NUREG/CR-XXXX
PNNL-XXXXX

**Ultrasonic Phased Array
Assessment of the Interference
Fit and Leak Path of the
North Anna Unit 2 Control Rod
Drive Mechanism Nozzle 63 with
Destructive Validation**

Office of Nuclear Regulatory Research

Figure 1.1 CRDM J-groove Weld Schematic

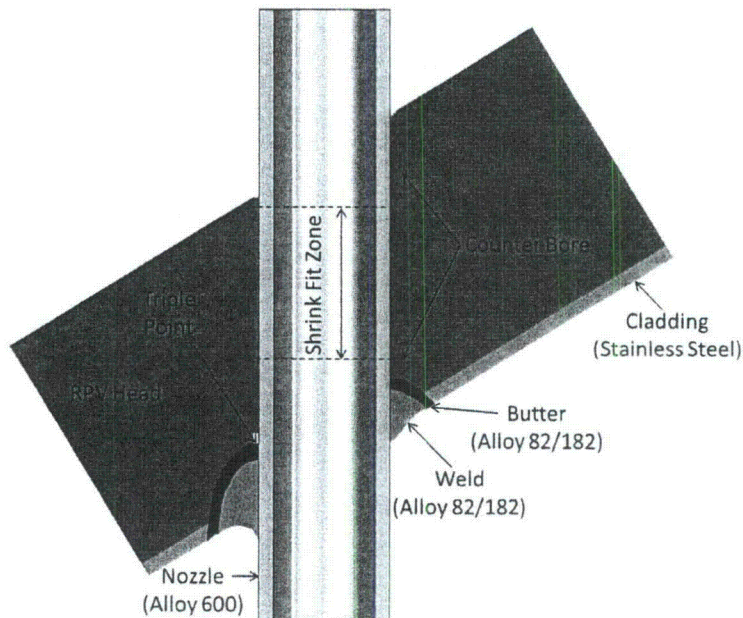
Comment [PG03]: Why doesn't the shrink fit go down to the top of the J-groove weld?

Figure 3.2 5.0-MHz Phased Array Probe

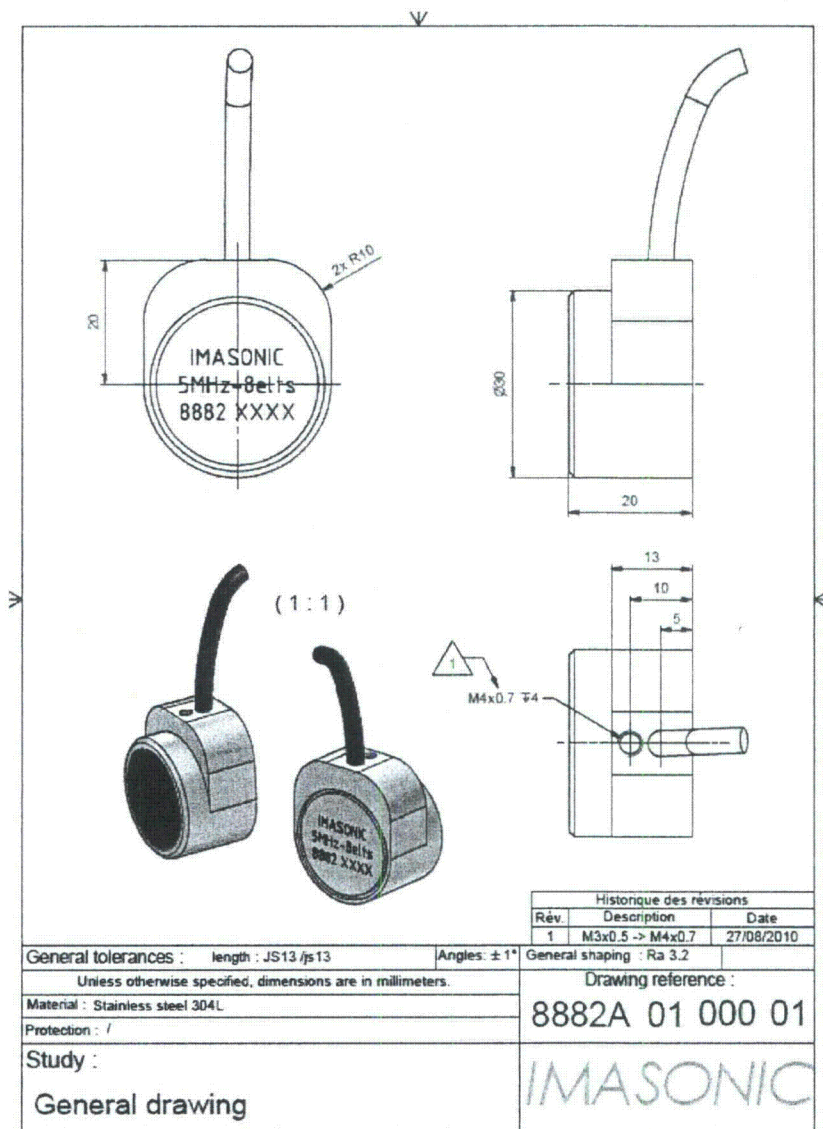
Comment [PG04]: Do you have (or need) permission to use this figure?

Figure 3.4 Law Formation and Sound Field Simulation for a Depth Focus of 15 mm

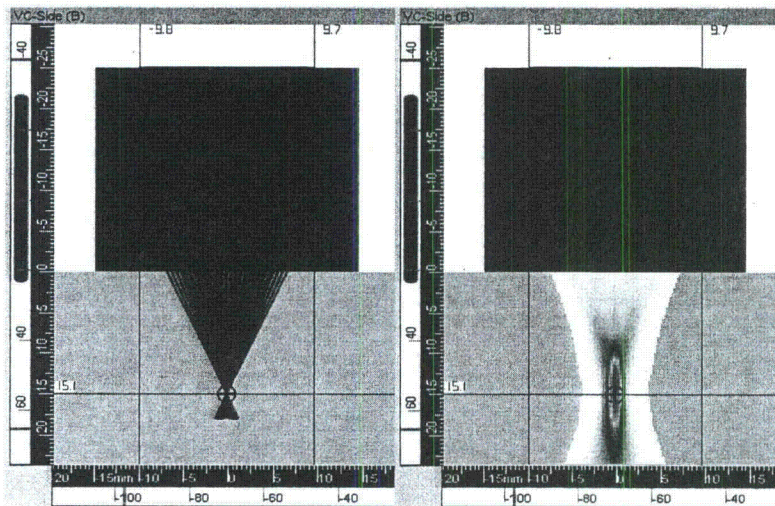
Comment [PG05]: Where is probe in this figure?

Figure 3.5 C-Scan View at a Depth Focus of 15 mm. Top: -6 dB spot size. Bottom: -3 dB spot size.

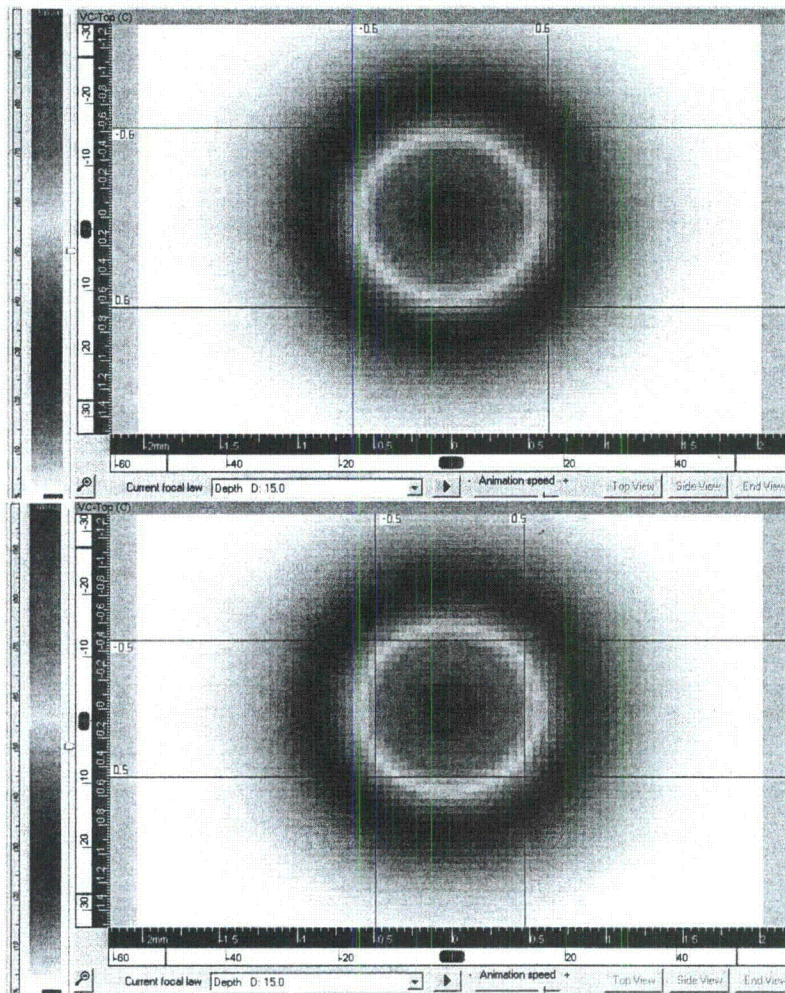
Comment [PG06]: What is significance of red and blue lines?

Figure 3.8 Scanning Setup/Orientation Schematic

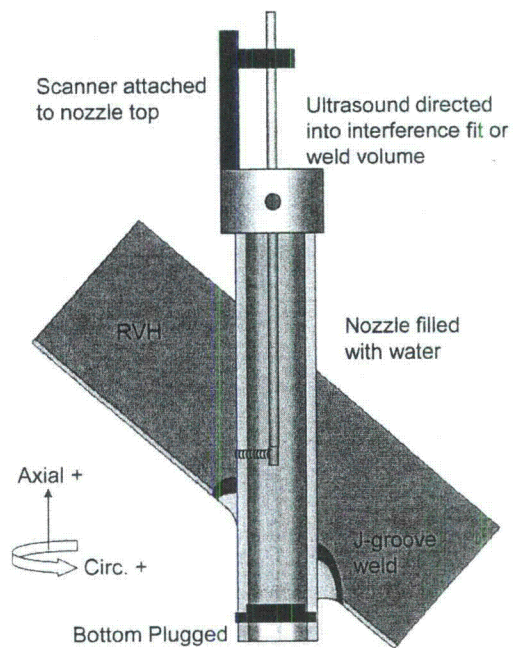
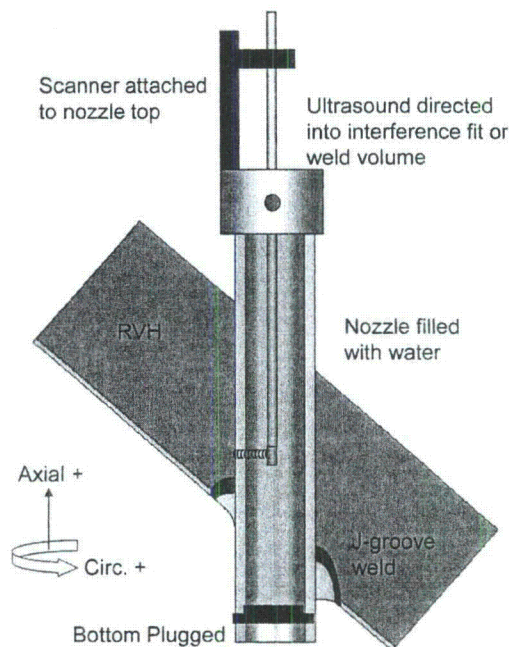
Comment [PG07]: Same as figure 5.3

Comment [PG024]: You have already used this image (Fig. 3.8). Do not repeat it. Reference previous figure if necessary.

Figure 3.9 Scanner System on Nozzle 63 in the Custom Glove Bag

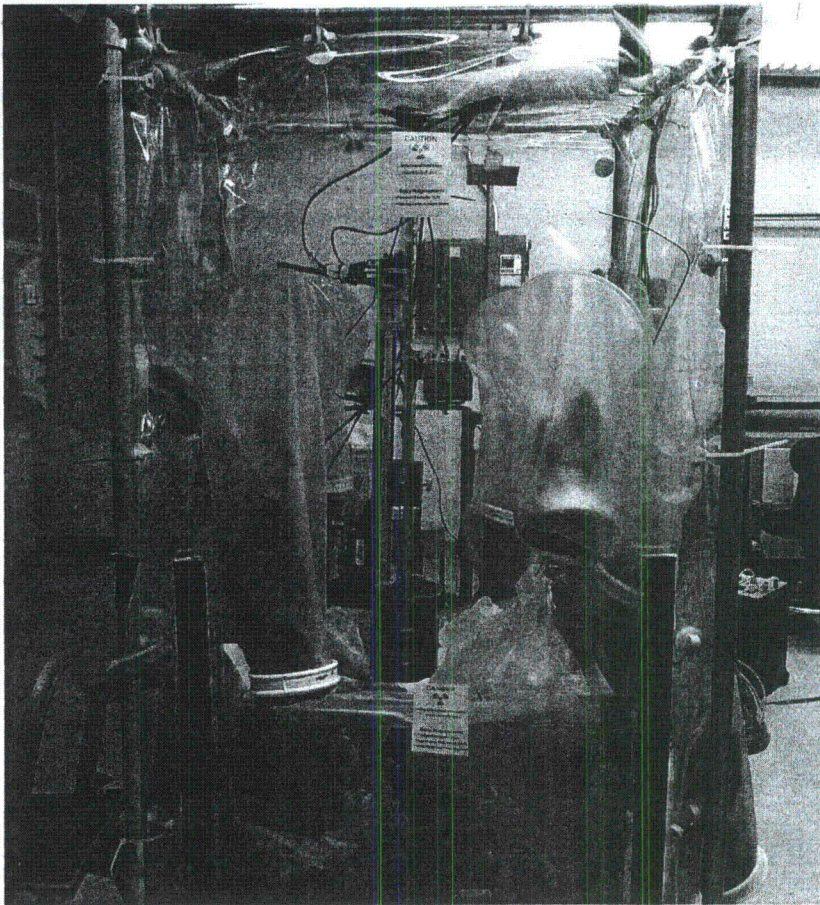
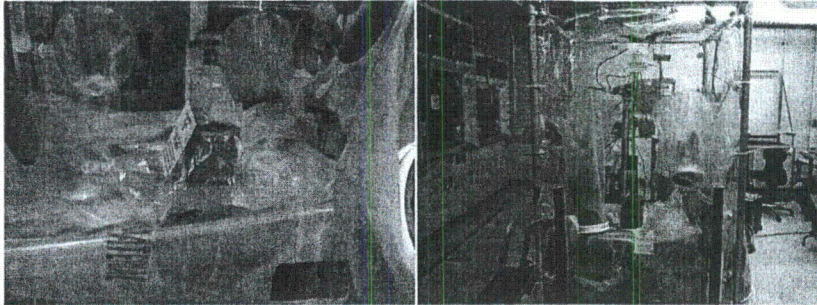
Comment [PG08]: Same as figure 5.2.

Comment [PG023]: Same as Figure 3.9

Figure 4.3 Boric Acid Application

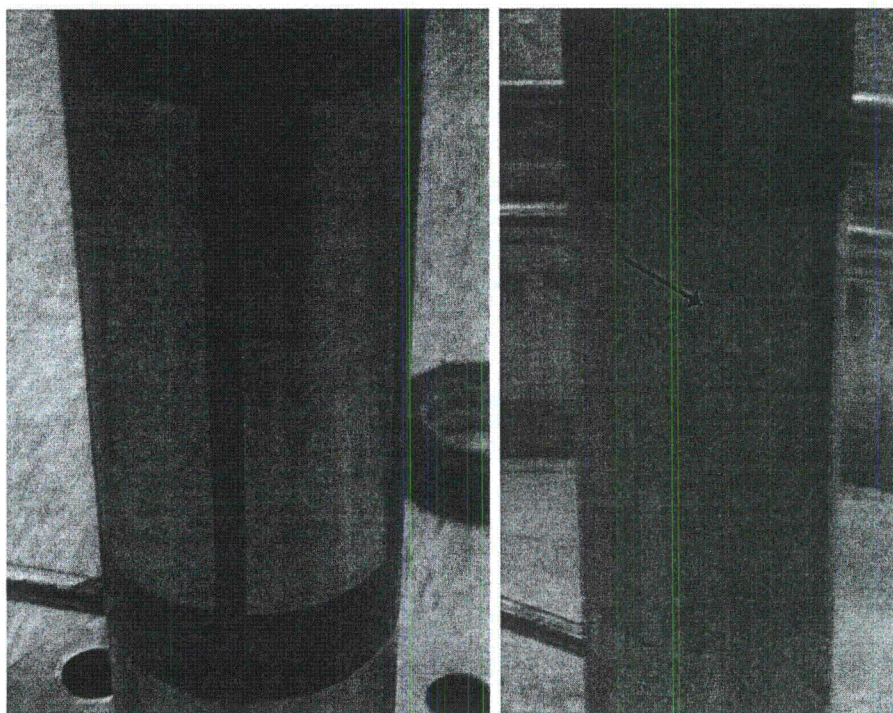
Comment [PG09]: State that in the image on the left the blue tape indicates masked regions and that the arrow on the right indicates the path where the boric acid was scraped off.

Figure 4.5 Notch Pattern in the CRDM Calibration Mockup Specimen, Upper Interference Fit. All units are inches. Above: General notch layout with detail. Below: Circumferentially orientated resolution notch detail.

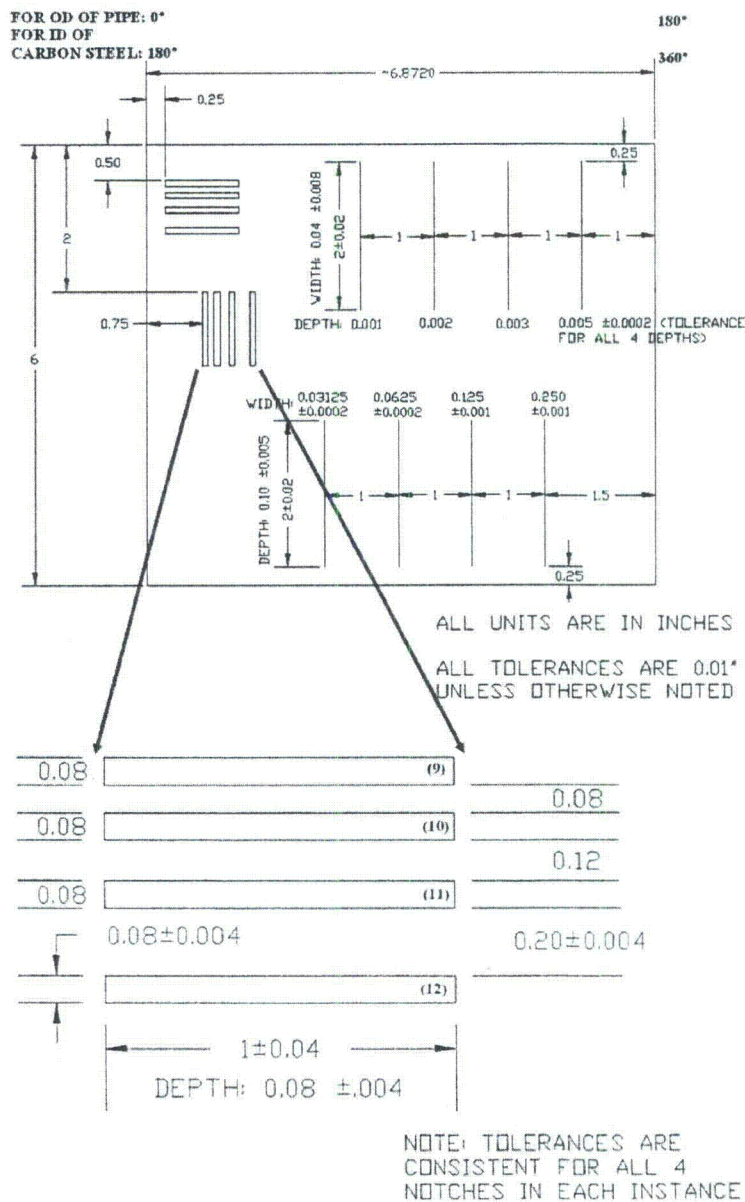
Comment [PG010]: Can this be in appendix?
Do you need here?

Figure 4.9 Tube Shrinkage Measurements

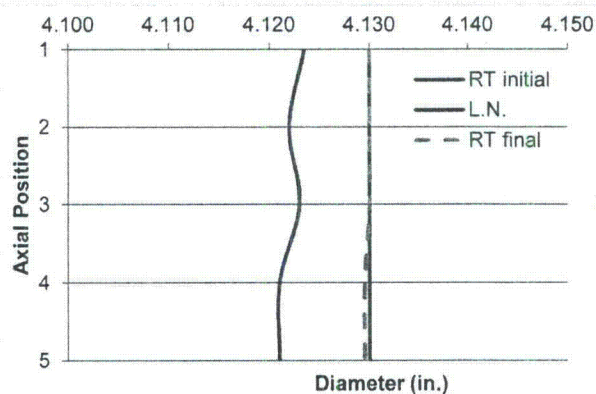
Comment [PG011]: This extended discussion isn't necessary.

Figure 4.13 Top View, Plan View, or C-scan Ultrasonic Image of the Upper Interference Fit Region Containing Calibration Notches in the Alloy 600 Tube

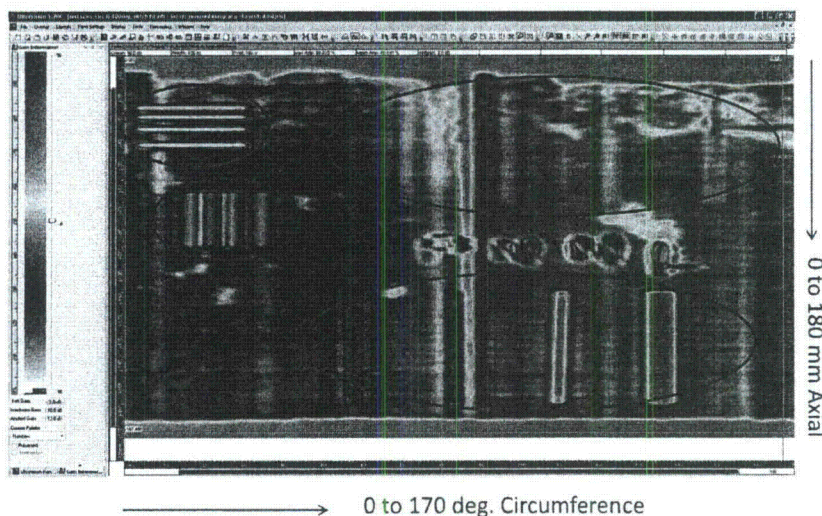
Comment [PGO13]: Please state in the figure caption what is circled

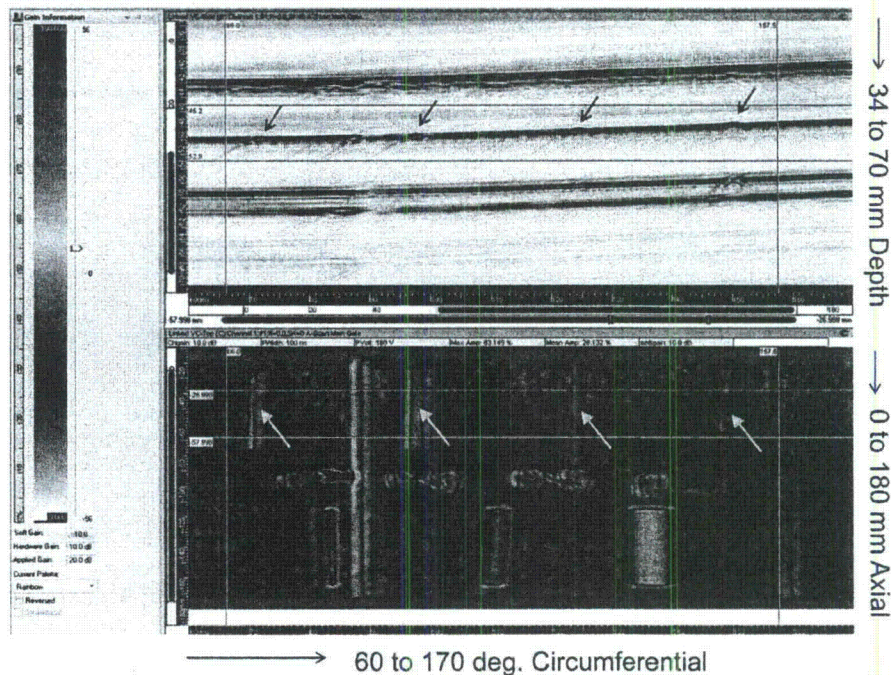
Comment [PG014]: State what arrows are pointing to in bottom image.

Figure 4.18 C-scan Plan View of the Notches in the Carbon Steel from the First Ultrasonic Echo

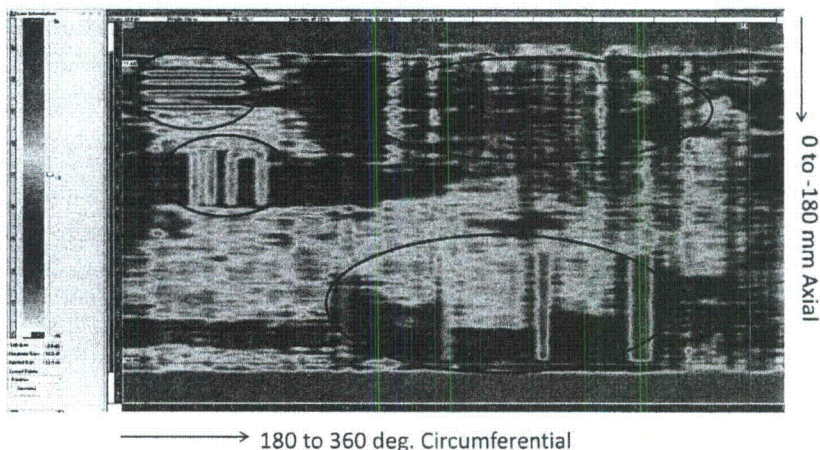
Comment [PG015]: State what is circled.

Figure 4.21 C-scan Plan View of the Width Notches in Carbon Steel, on the Bottom. This image was acquired from the second ultrasonic echo.

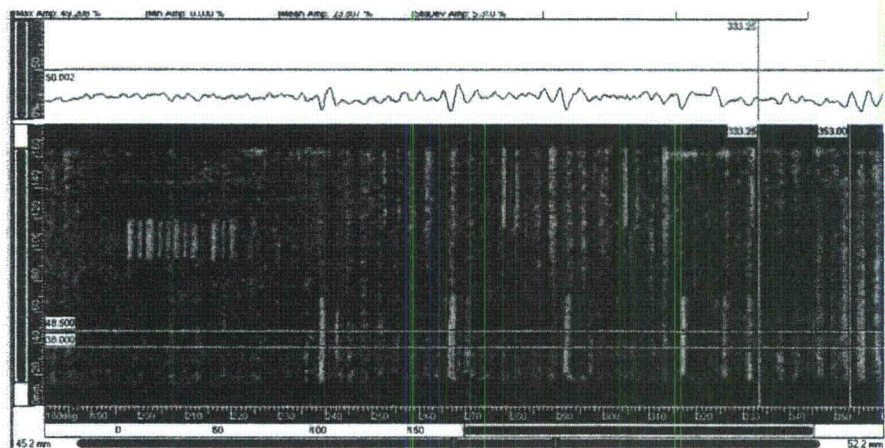
Comment [PG018]: Say what arrows are pointing to.

Figure 4.22 C-scan Plan View of the Boric Acid Deposits in the Lower Interference Fit Region. The horizontal axis represents the circumferential range of 60–240 degrees. This image is from the first ultrasonic echo.

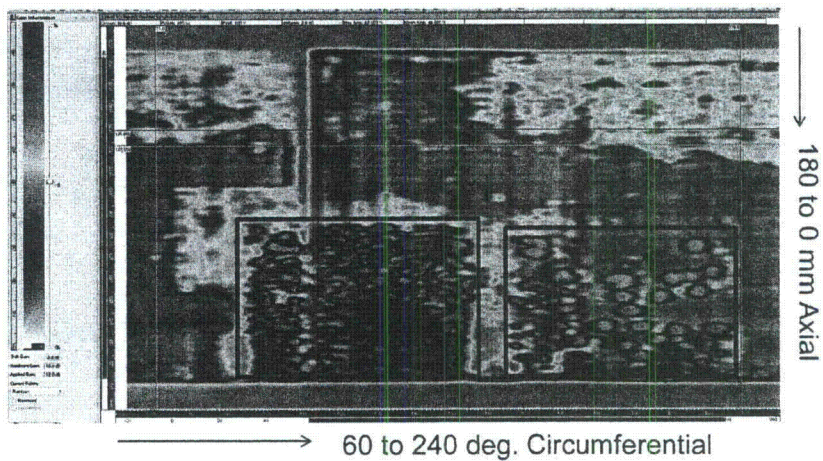
Comment [PG019]: Say what is boxed.

Figure 4.23 C-scan Plan View of the Boric Acid Deposits in the Lower Interference Fit Region. The horizontal axis represents the circumferential range of 240–60 degrees. This image is from the first ultrasonic echo.

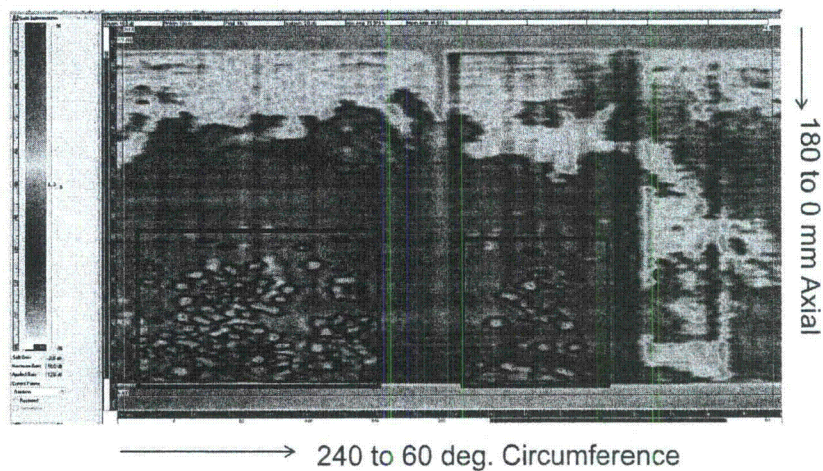
Comment [PG020]: Say what is boxed.

Figure 4.25 Putty on a Nozzle Outer Surface is Detected. The horizontal axis represents 250 mm (9.8 in.) and the vertical axis represents 90 mm (3.5 in.).

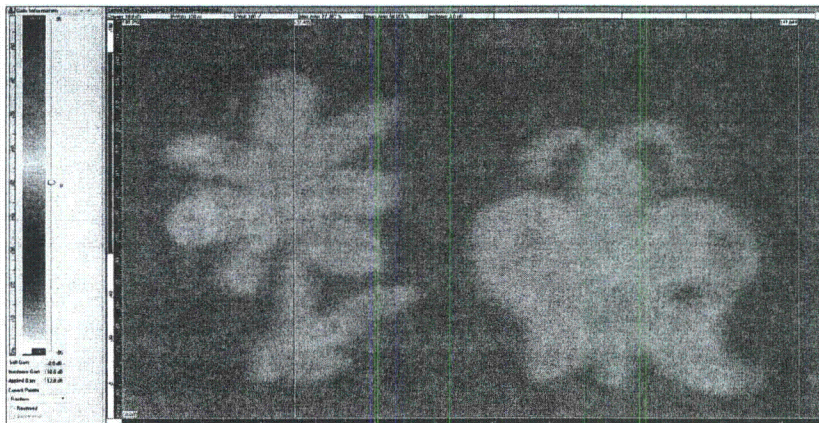
Comment [PG021]: Please don't show this figure. It is distracting. Do you have an image with different shapes or can we describe with words only.

Figure 5.1 Calibration Data on the Blank Nozzle Piece Before (left) and After (right) Transport to RPL/33. The horizontal axis represents 150 degrees of circumference and the vertical axis represents 50 mm (1.97 in.) in the axial direction in each image.

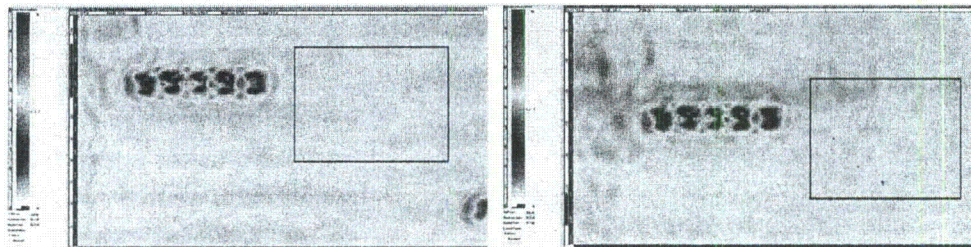
Comment [PG022]: Don't need all the description and figure. Just can say that the scanner functionality was validated after moving.

Figure 5.4 Alloy 600 Tube ID Response Before (left) and After (right) Centering the Scanner on the Nozzle. The horizontal axis represents approximately 180 degree and the vertical axis 20 mm (0.79 in.).

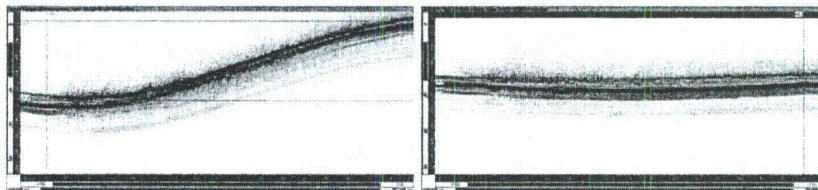
Comment [PGO26]: You don't need this figure. Just say that the probe was centered.

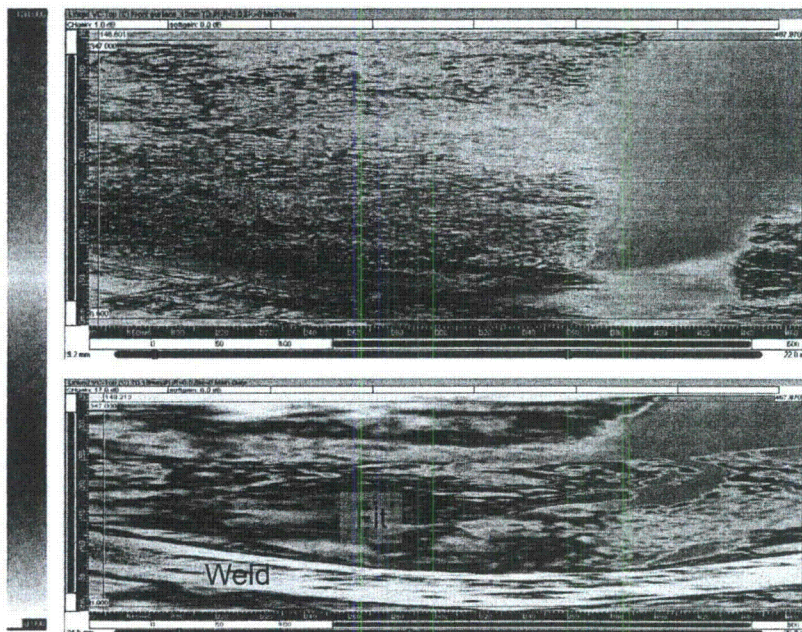
Comment [PG027]: Remove figure

Figure 5.6 PA Ultrasonic Data from Nozzle 63 Acquired After Cleaning the Probe Face. The front surface or nozzle ID echo is on the top and the interference fit echo on the bottom. The horizontal axis represents the 86 to 274 degree area and the vertical axis represents 360 mm (14.17 in.).

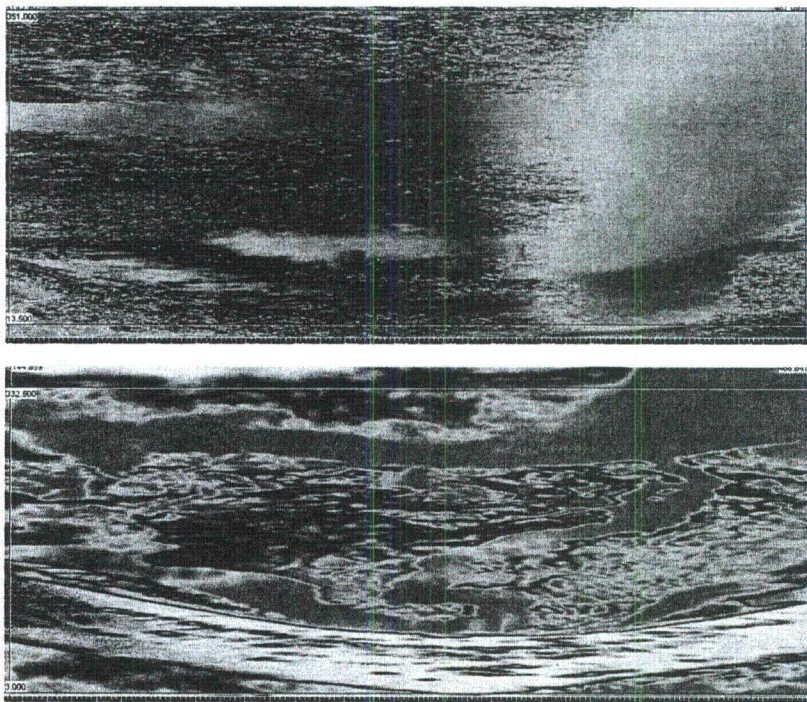
Comment [PG028]: Remove figure.

Figure 5.7 Bubbles are Detected on the ID of the Nozzle, some of which are Indicated by Arrows. The vertical axis represents 25 mm (0.98 in.) and the horizontal axis represents 190 degrees.

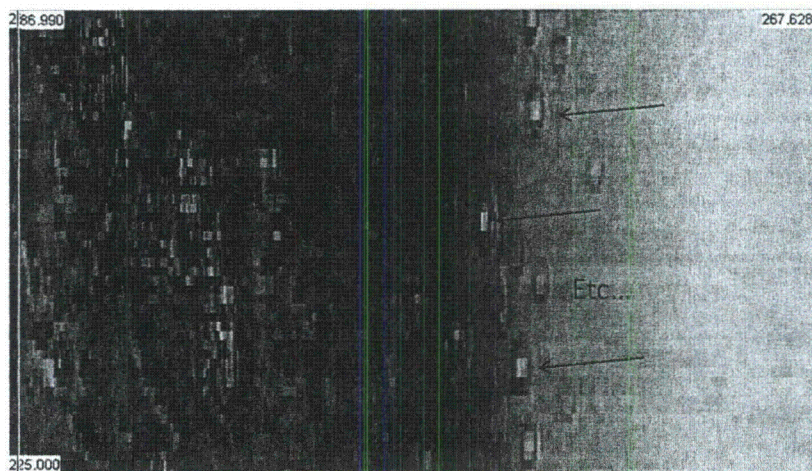
Comment [PGO29]: Remove figure.
